U.S. Department of the Interior BUREAU OF LAND MANAGEMENT Sundry Print Report

Well Name: BONANZA Well Location: T22N / R3W / SEC 12 / County or Parish/State:

**Sundry ID: 2655615**

Type of Action: Plug and Abandonment

## Proposed Wellbore Diagram DJR Operating, LLC Bonanza 11

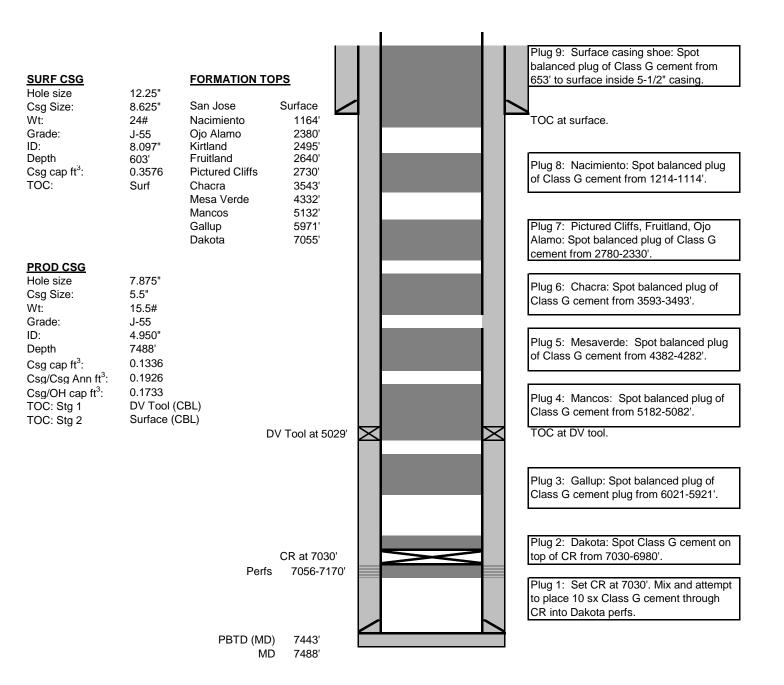
BLM pick for the Fruitland and Chacra formation tops vary from Operator.

- Adjust Plug #6, or add a plug, to cover BLM pick for the Chacra formation top (3143').
- Bring the bottom of proposed Plug #7 down to 2807' to cover BLM pick for the Pictured Cliffs formation top (2757').
- The plugs proposed in the P&A procedure, with changes recommended above, will adequately protect any freshwater sands in this wellbore.
- Dakota perfs 7056' 7170'.

- 1. Plugging operations authorized are subject to the attached "General Requirements for Permanent Abandonment of Wells on Federal and Indian Lease."
- 2. Farmington Office is to be notified at least 24 hours before the plugging operations commence at (505) 564-7750.
- 3. The following modifications to your plugging program are to be made:
  - a. Adjust Plug 6, or add a plug, to cover BLM pick for the Chacra formation top (3143 feet).
  - b. Plug 7: Bring the bottom down to 2807 feet to cover BLM pick for the Pictured Cliffs formation top (2757 feet).

You are also required to place cement excesses per 4.2 and 4.4 of the attached General Requirements.
